Appendix A. HAZOP Recommendations

DRG. No. A1 PKGT-LOG-ORF-PRO-PAIA-0006 Rev B

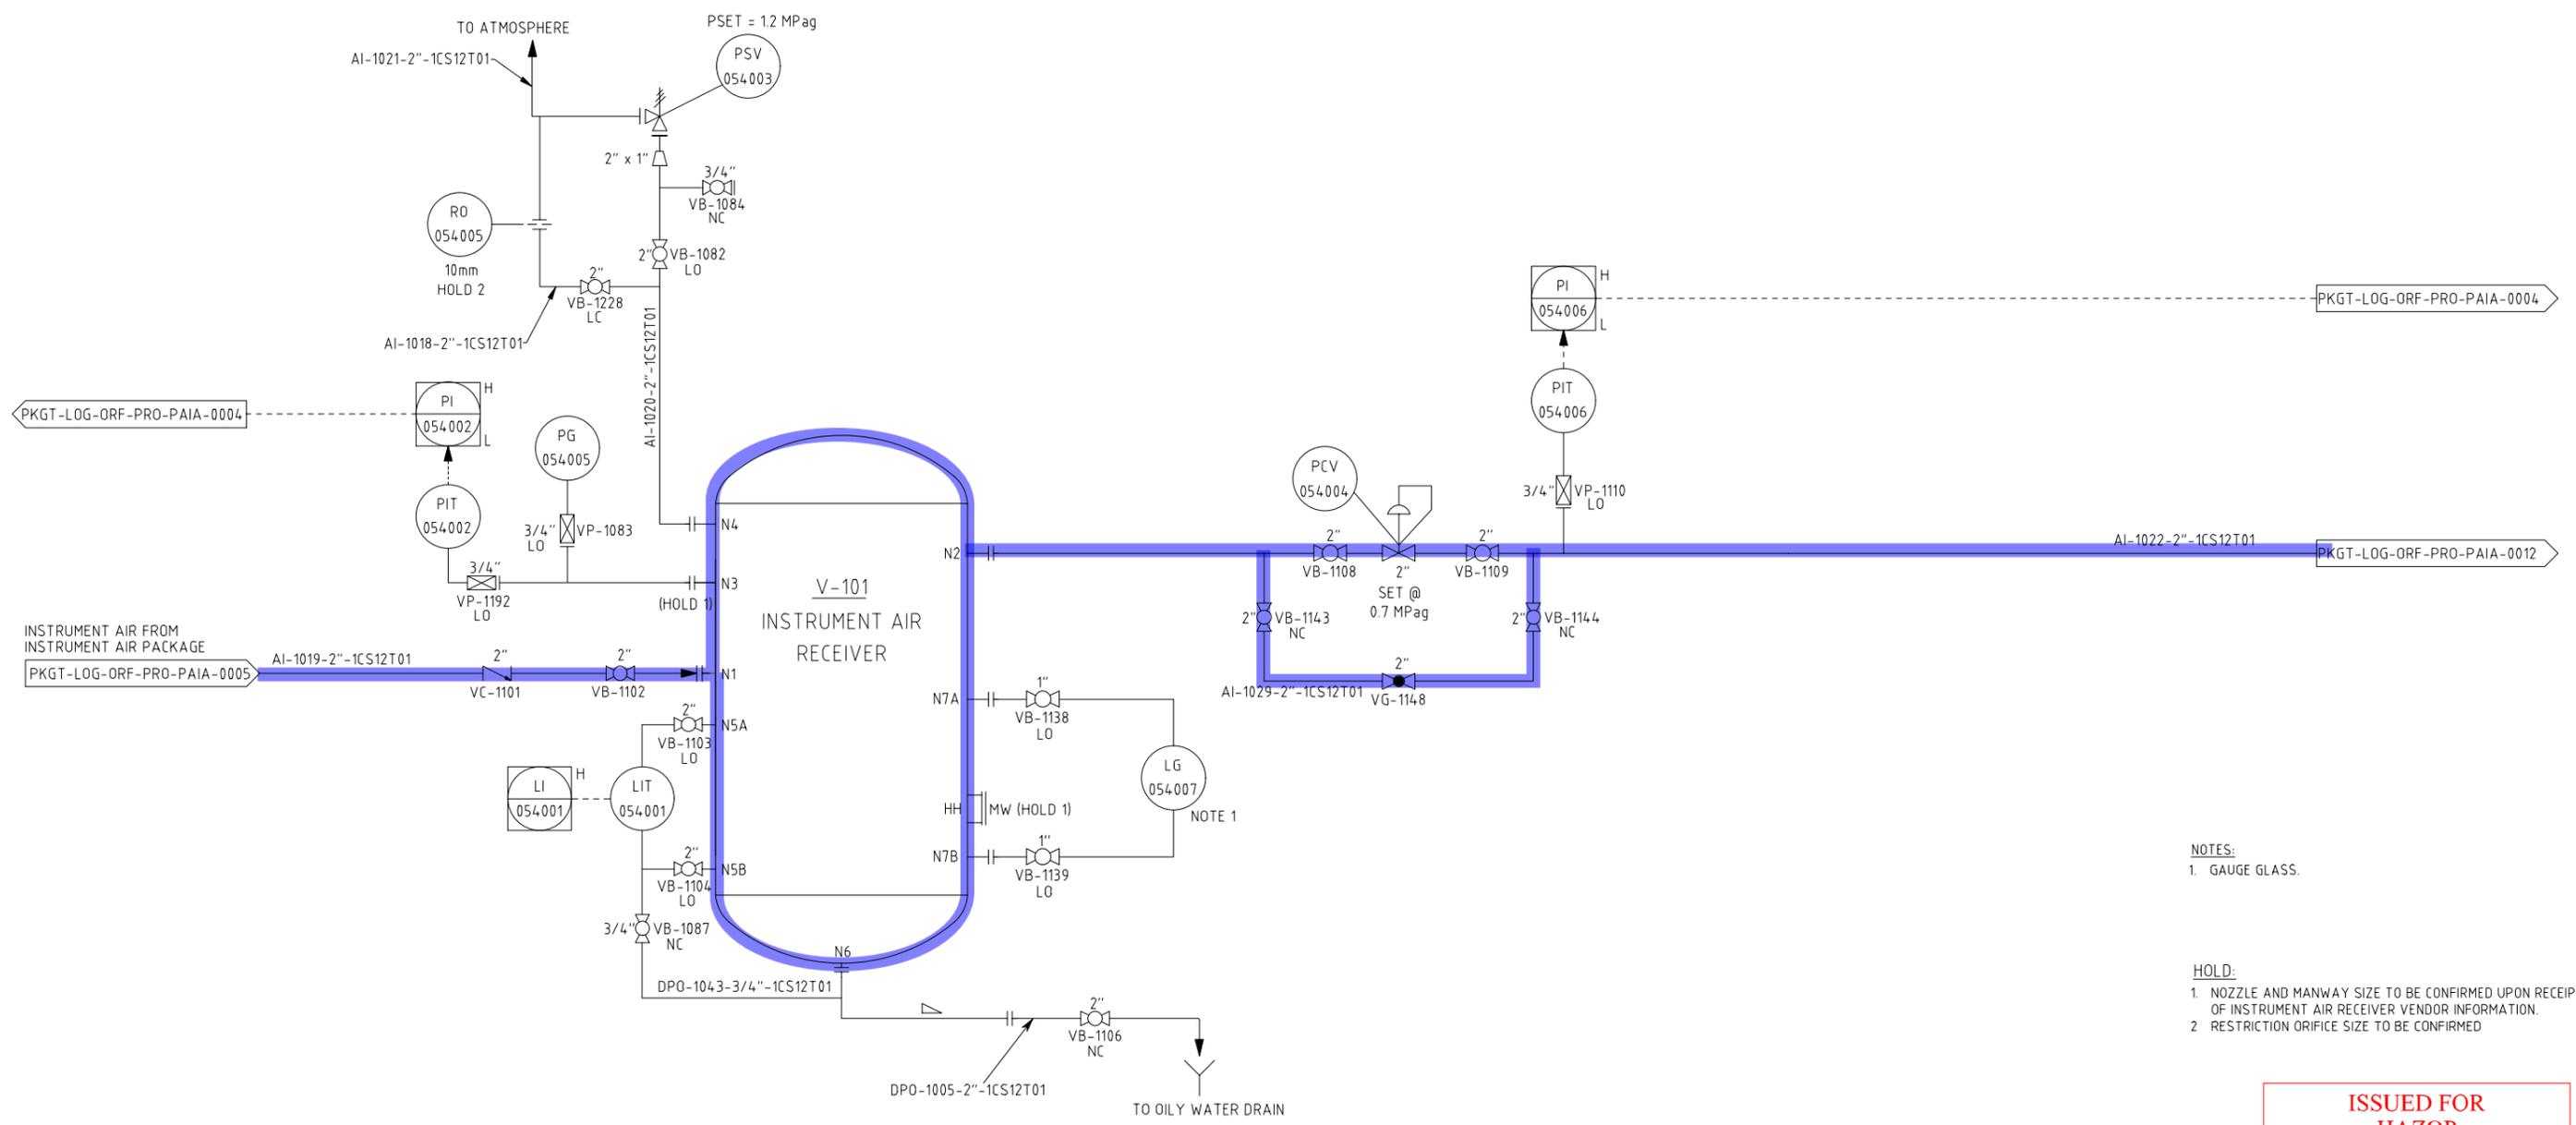
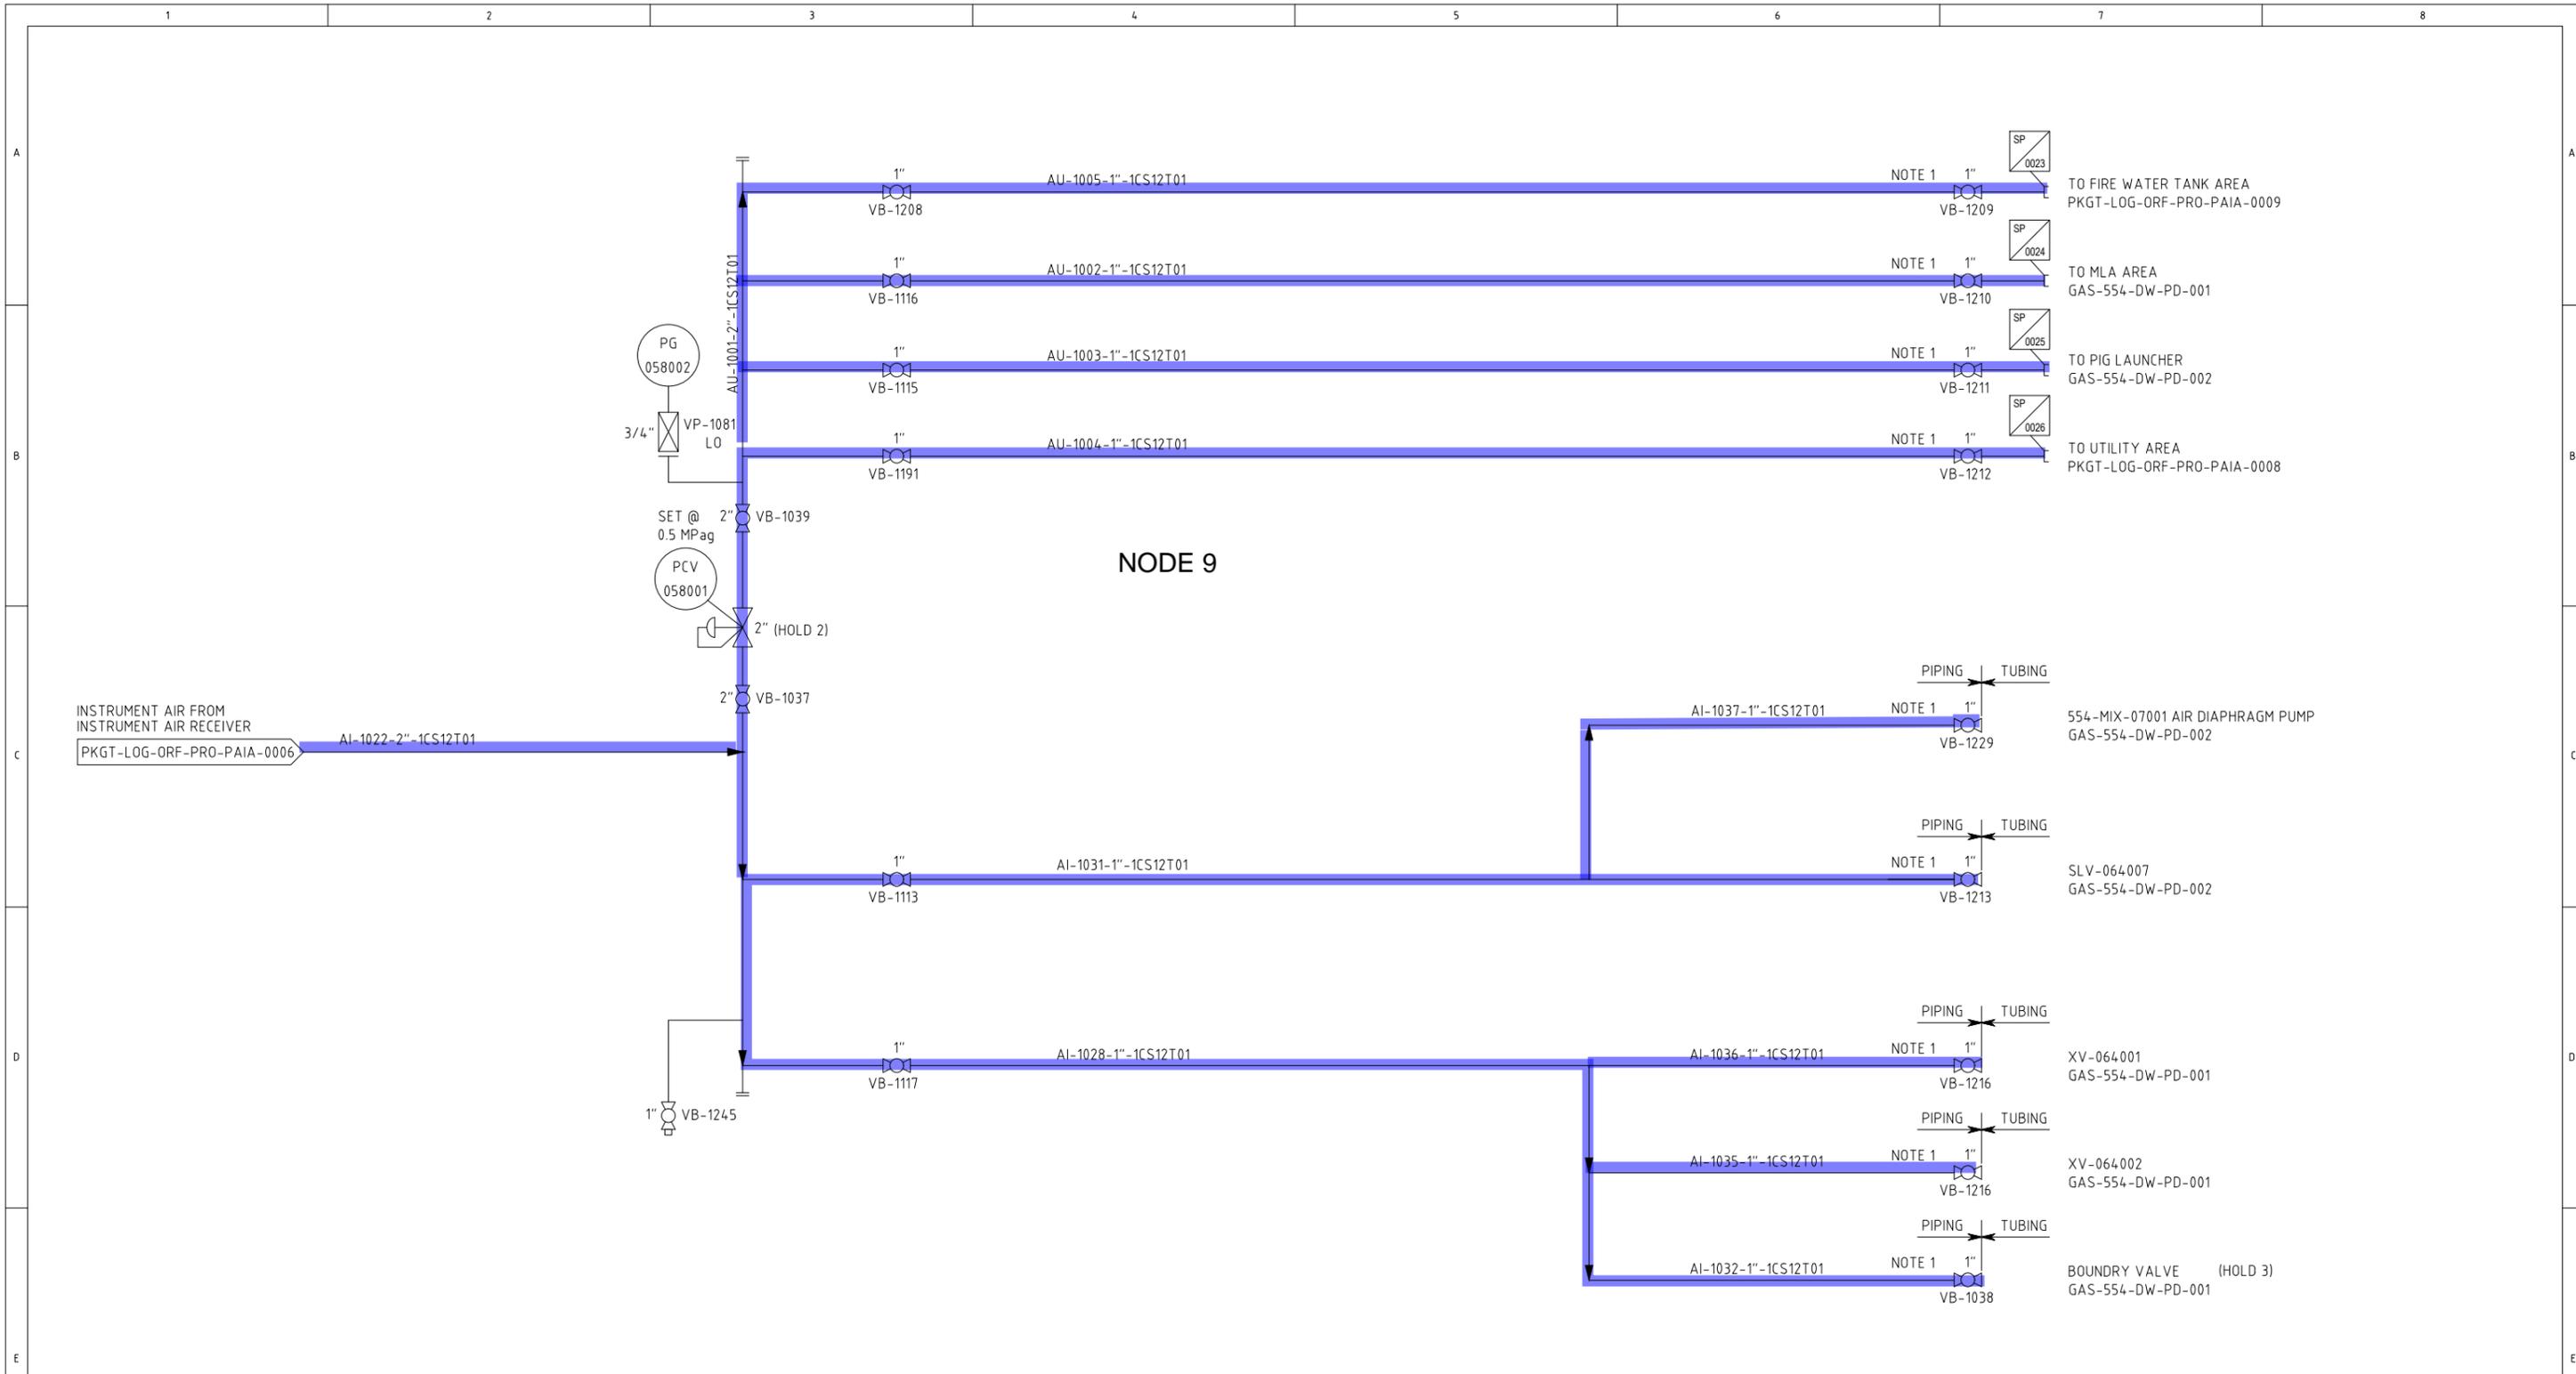
| Node | Recommendations | Place Used | Status | Noggin Status |
|---|---|------------------------|------------------------------------|---------------|
| 9. Instrument / Utility Air Distribution System | 88. Ensure overpressure protection is provided in upstream air compressor package. | Causes: 9.1.1 | No change. | In Progress |
| 9. Instrument / Utility Air Distribution System | 89. Consider spring return valve on instrument air receiver drain connection. | Causes: 9.8.1 | No change. | In Progress |
| 9. Instrument / Utility Air Distribution System | 90. Confirm dryer package has low temperature protection, and discharge temperature indication to SCADA | Causes: 9.10.1 | No change. | In Progress |
| 9. Instrument / Utility Air Distribution System | 91. Confirm requirement for level gauge, and materials of construction given design pressure of instrument air receiver | Causes: 9.16.1 | No change. | In Progress |
| 9. Instrument / Utility Air Distribution System | 92. Consider reducing minimum design temperature for receiver from 0°C (without change in material) to reduce reliance on low temperature instrumented protections and limitation on vessel blowdown rates. | Causes: 9.10.2 | No change. | In Progress |
| 9. Instrument / Utility Air Distribution System | 93. Ensure level transmitter is commissioned separate from instrument air receiver, or specify alternate means of inferring level /absence of free water in instrument air receiver. | Causes: 9.17.1 | No change. | In Progress |
| 9. Instrument / Utility Air Distribution System | 94. Provide pressure control from air receiver PIT only, with alarm on PIT downstream of PCV-054004. | Causes: 9.20.1 | No change. | In Progress |
